SERVICE LETTER 239

Cessna 206 Hydraulic Pump Replacement on 4000A Floats

Aircraft Makes/Model(s):	Float Model(s):	Compliance: Optional	By: MAS
Textron Aviation 206 Series	4000A	Part Number: 1011956	Approved: DRH
		Date: 1/7/2026	Revision: B

DISCONTINUED OILDYNE HYDRAULIC PUMP 4A09000-081

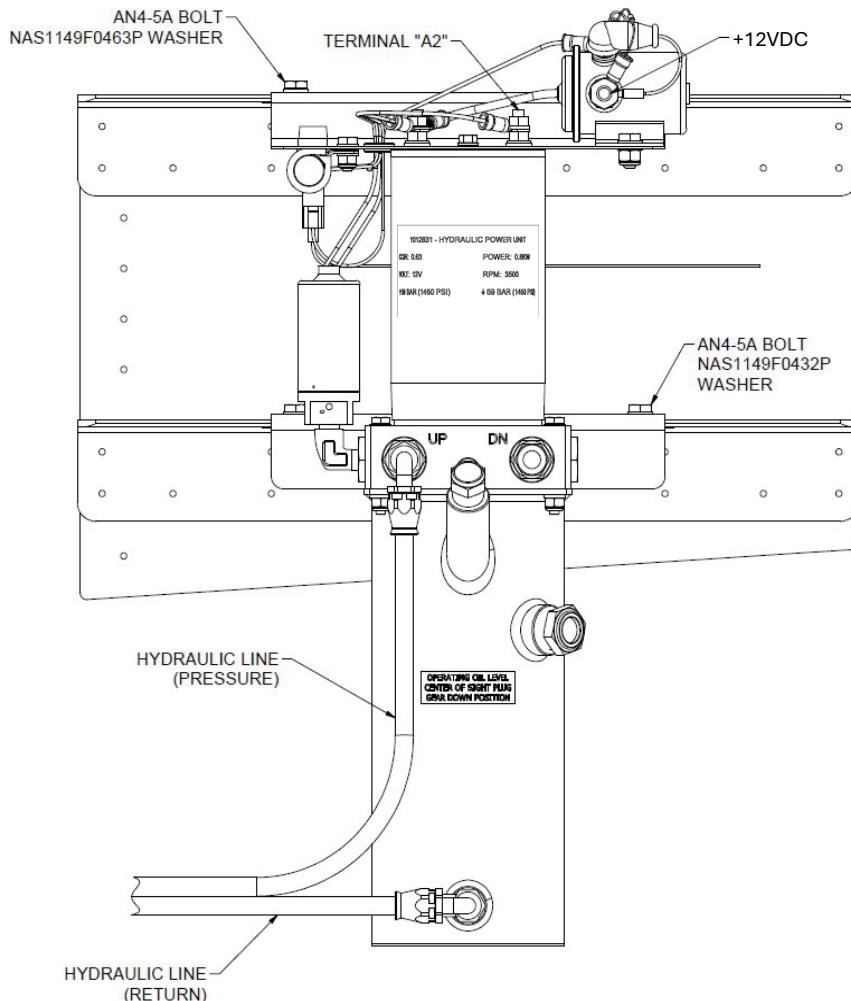
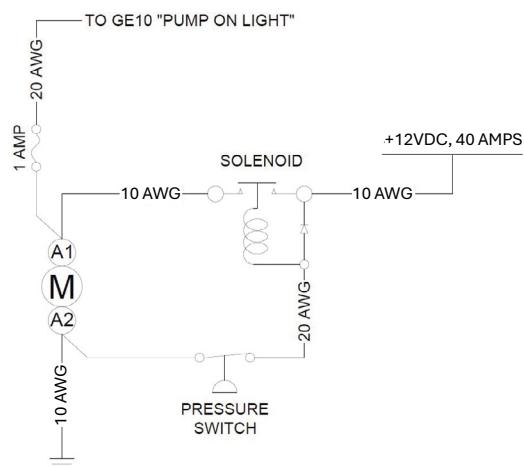
Textron Aviation (Cessna) 206 Hydraulic Pump Assembly 24 VDC p/n 4A09000-081 has been discontinued. This service letter provides the option to replace it with pump p/n 1011955 for the 24 VDC. This service letter also contains instructions for replacing the hydraulic pump assembly on 12 VDC systems, using pump p/n: 1012886.

NEW 24 VDC HYDRAULIC PUMP 1011955
